05-029r19 SAS-1.1 transmitter and receiver transients subsection January 6, 2005

To: T10 Technical Committee  
From: Alvin Cox, Seagate (Alvin.cox@seagate.com)  
Date: January 18, 2005  
Subject: 05-029r0 SAS-1.1 transmitter and receiver transients subsection

Figure 63 — Transmitter transient test circuit

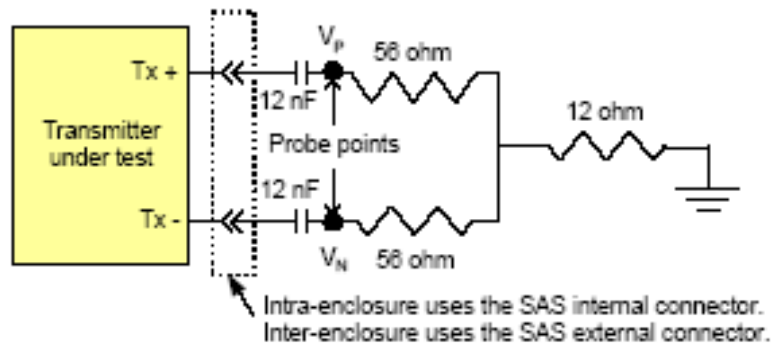
Move Figures 63 (Transmitter transient test circuit) and 64 (Receiver transient test circuit) to 5.3.x.

The maximum transmitter and receiver transients are measured at nodes VP and VN with respect to GROUND on the test loads shown in figure 63 (for the transmitter device) and figure 64 (for the

receiver device) during all power state and mode transitions. Test conditions shall include the system power supply ramping at the fastest possible rate for both power on and power off conditions, voltage sequencing, and mode transitions.
